Docket No. 50-250
50-251

Change No. 5
License Nos. DPR-31 and 41

By letter dated March 16, 1973, you proposed seven revisions to the Technical Specifications attached as Appendix A to Facility Operating Licenses DPR-31 and 41. This action is designated Change No. 5.

Re: Turkey Point Units 3 and 4
 Docket Nos. 50-250 and 50-251
Proposed Changes in Technical Specifications

PLANT ORGANIZATION CHART
FIG. 6.1-2

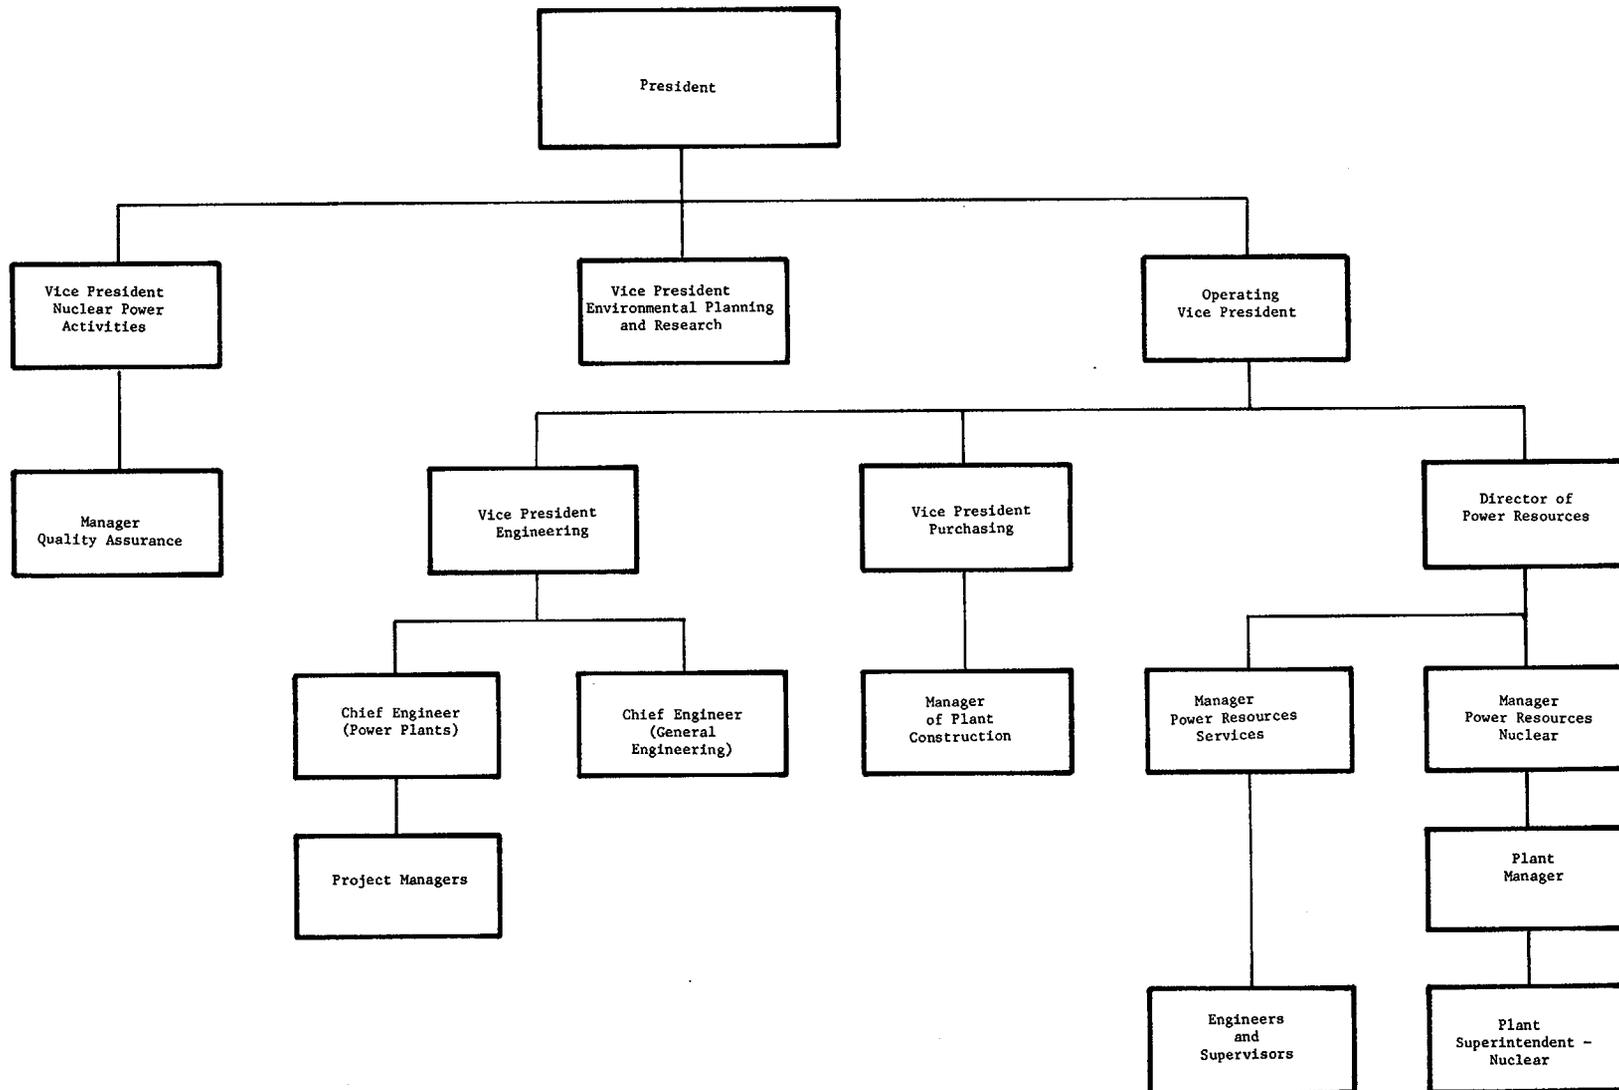
7. Pages 6.1-1, 6.1-2, 6.1-3, 6.1-4, 6.1-5, 6.1-6, 6.1-7, 6.1-8, 6.2-1, 6.3-1, 6.4-5, 6.4-6, Figures 6.1-1 and 6.1-2.

The above have been updated to show current plant organization and new titles of Power Resources (formerly Production Department) personnel.

6.1.3 Plant organization for conduct of operations is shown in Figure 6.1-2.
